Seismic Walkdown Checklist (SWC)

Equipment ID No. QSR42B516 Equip. Class[1] 20

Equipment Description UNIT 1 SERVICE WATER BATTERY FUSE BOX TRAIN A

Location: Bldg. SWIS Floor El. 188 Room, Area 74

F1-111

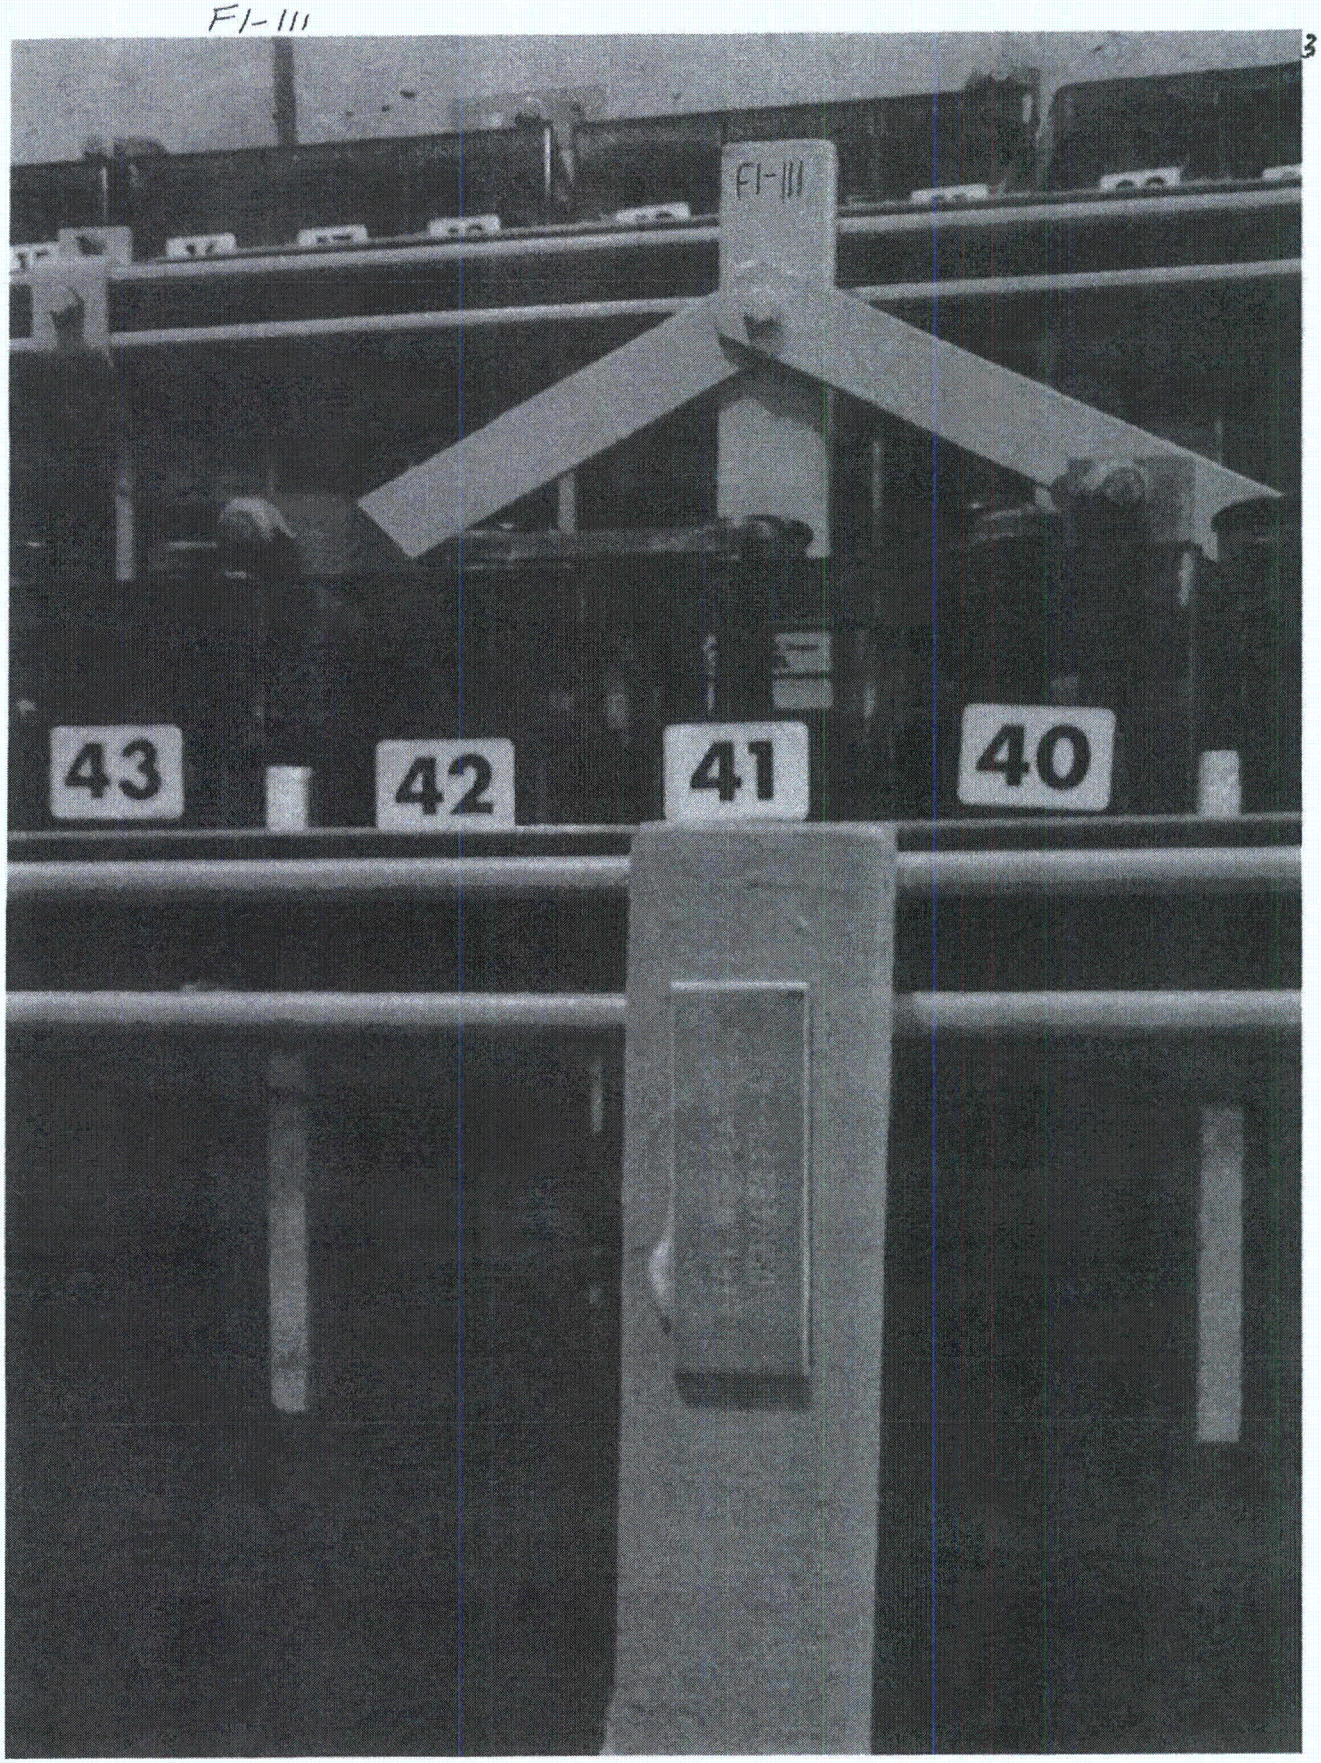
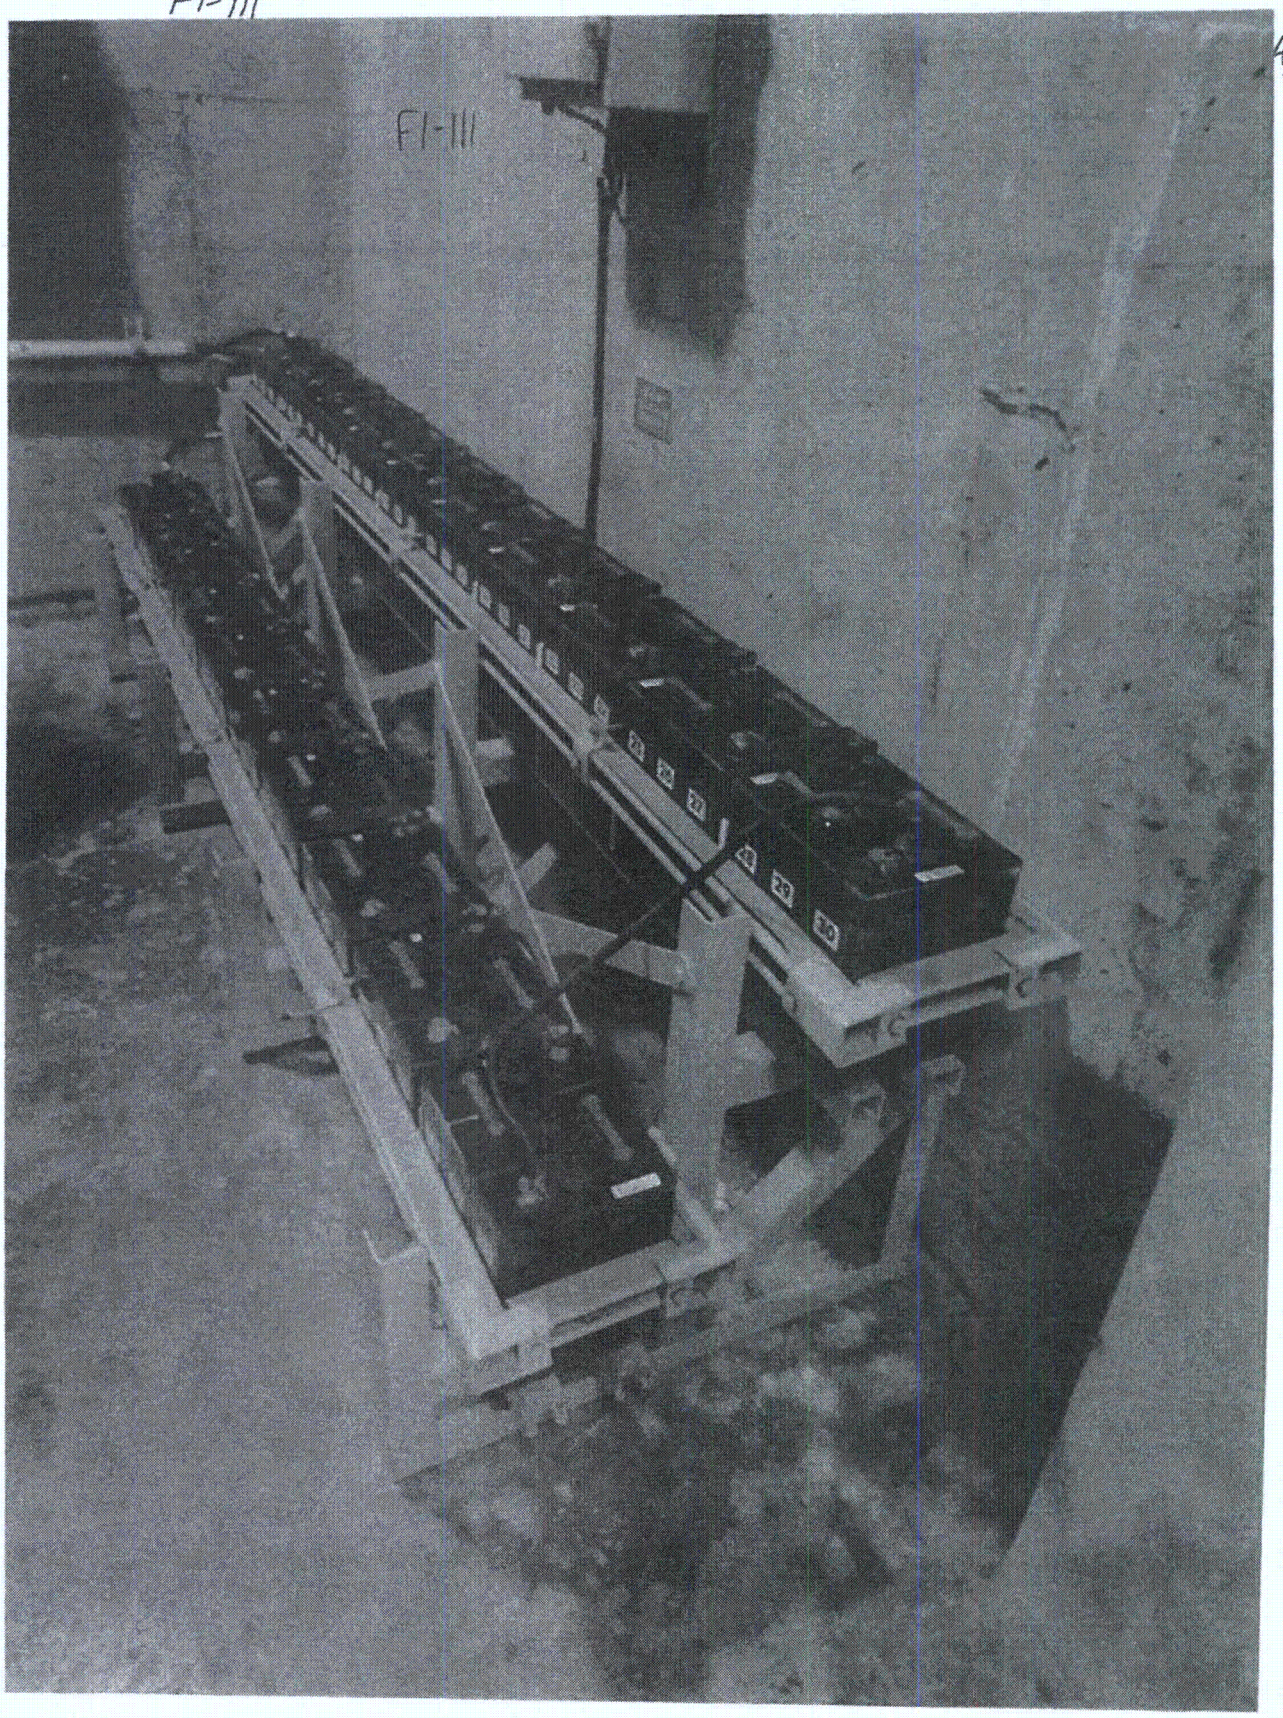
SENS package dated 4/94 indicates 16 mounting bolts based on the photo on the last page, with rows of four.
6. Based on the above anchorage evaluations, is the anchorage free of potentially adverse seismic conditions? Y☒ N☐ U☐

SERV WTR BATT 1
05R42B525A A
05R42B525A-A
BATTERY
TRANSFER
SWITCH
F1-112
1

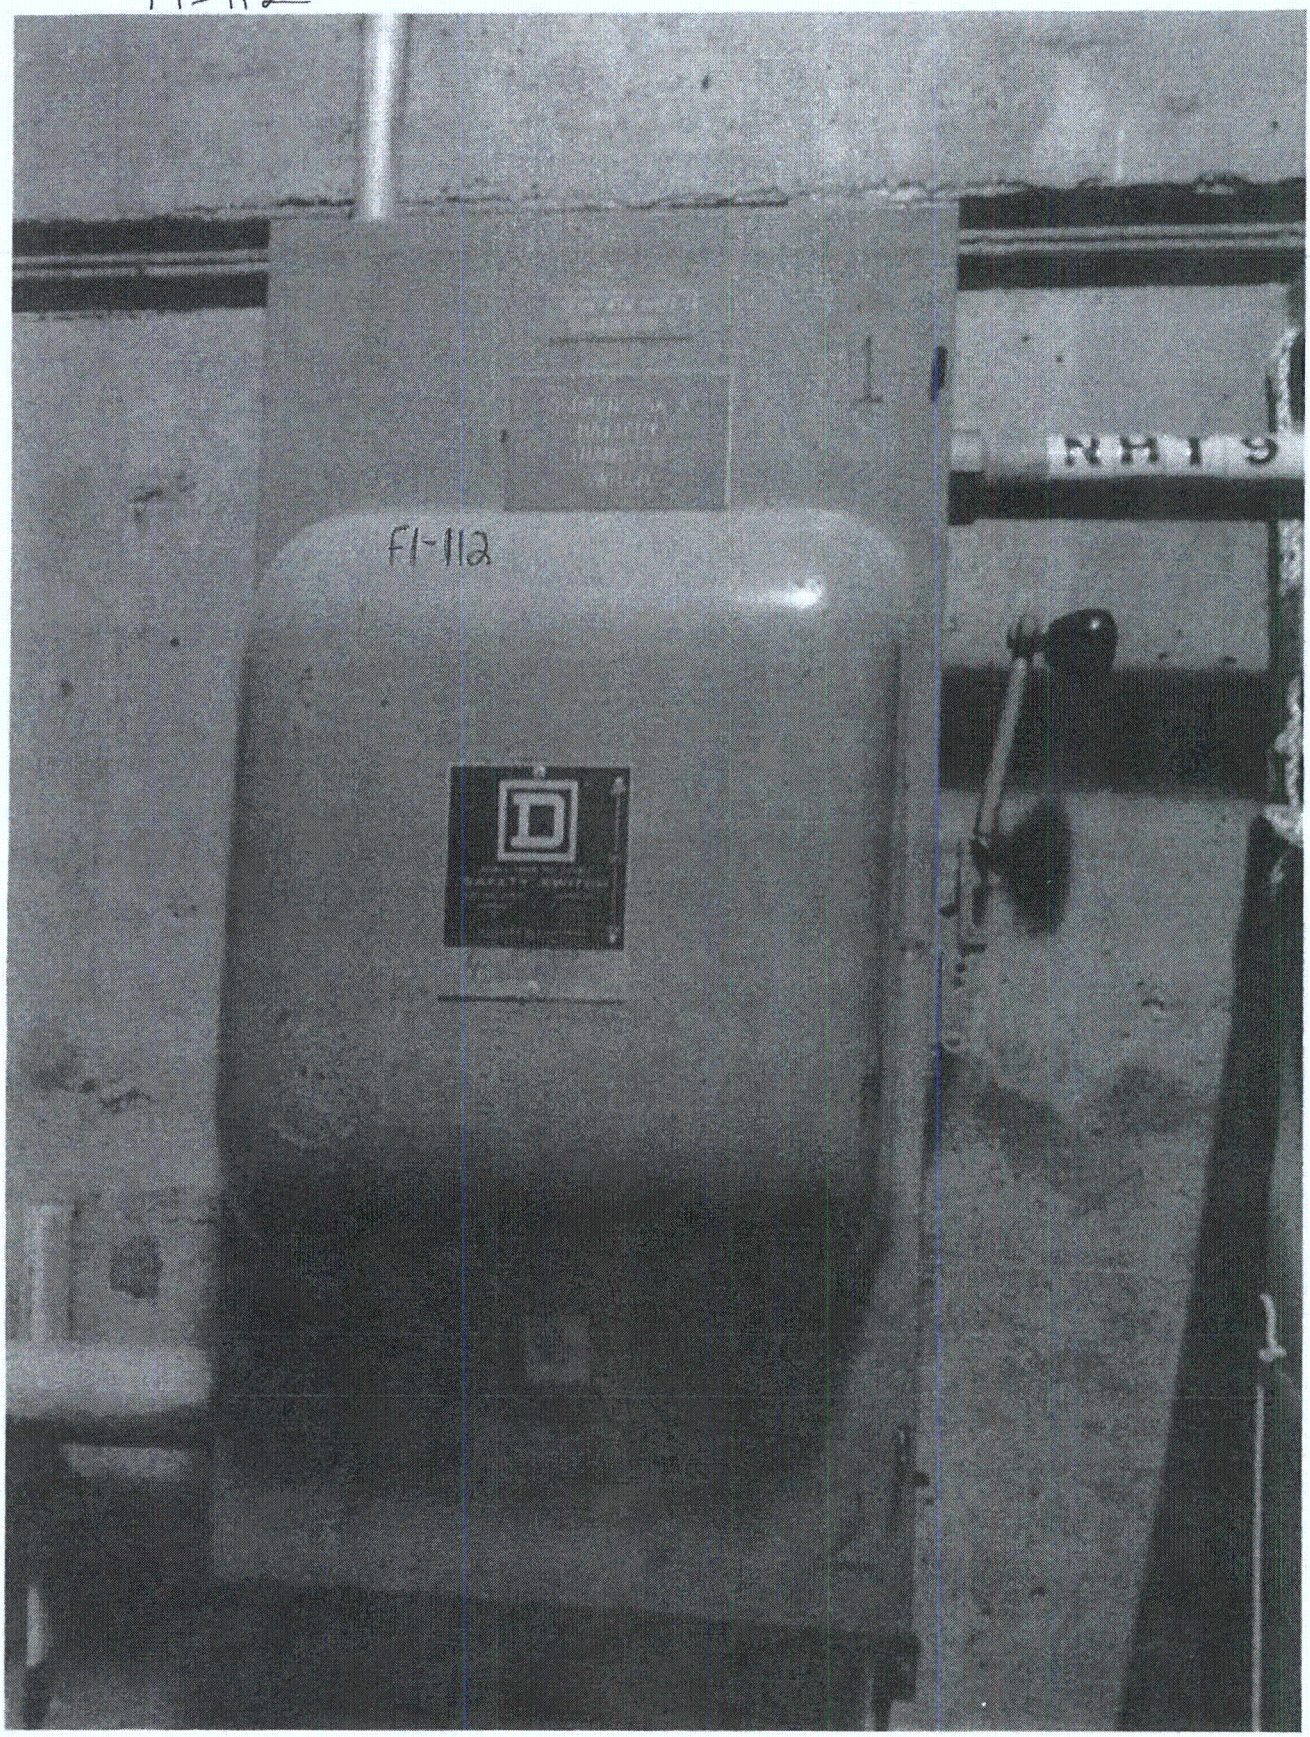
two lengths of horizontal unistrut attached to concrete wall. The Battery Transfer Switch is attached to unistrut with four spring nuts. See SEWS Package dated 4/1994

FI-113

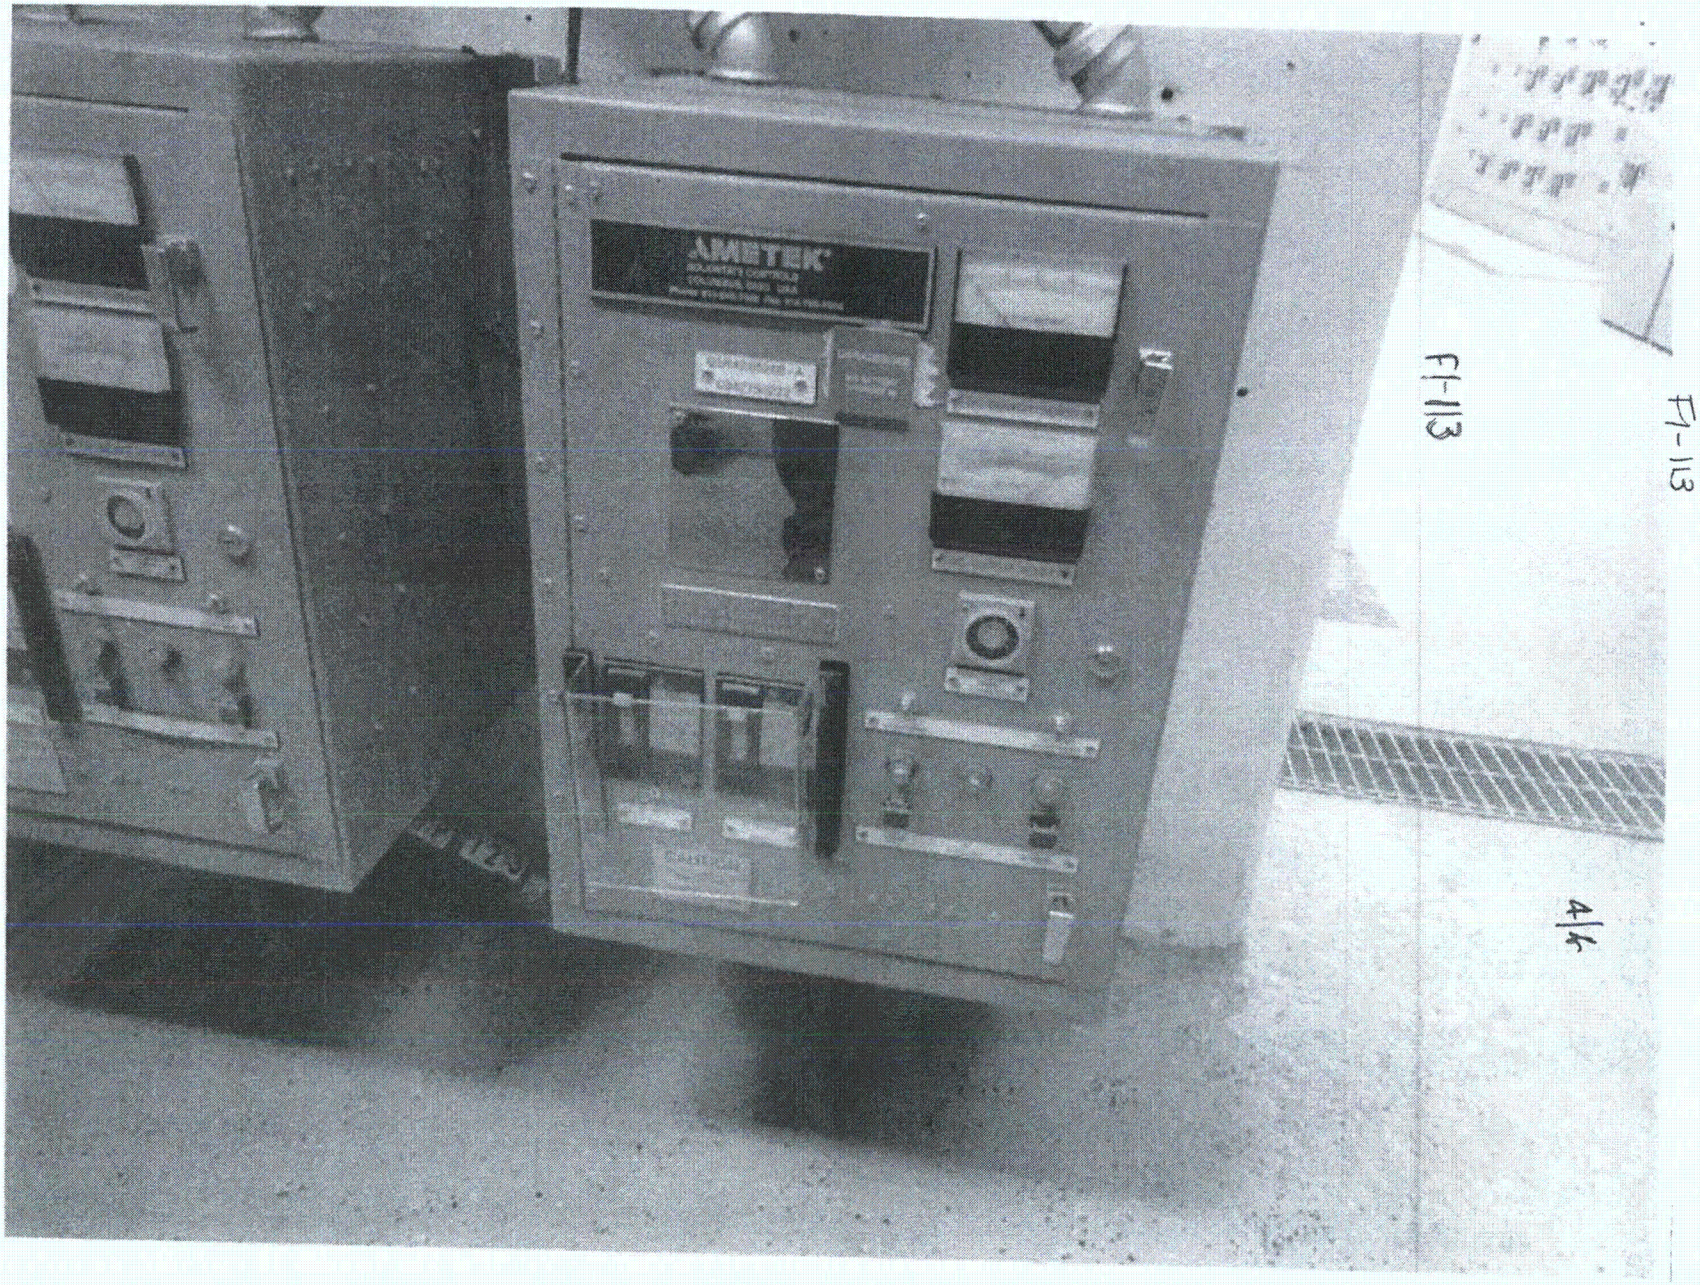
8. Are overhead equipment, distribution systems, ceiling tiles and lighting, and masonry block walls not likely to collapse onto the equipment? Y☒ N☐ U☐ N/A☐
   Overhead lighting is attached by conduit and hooks which does not meet the requirement for a positive end connection. However decking above prevents hooks from coming disengaged. This is judged to not collapseon any equipment.
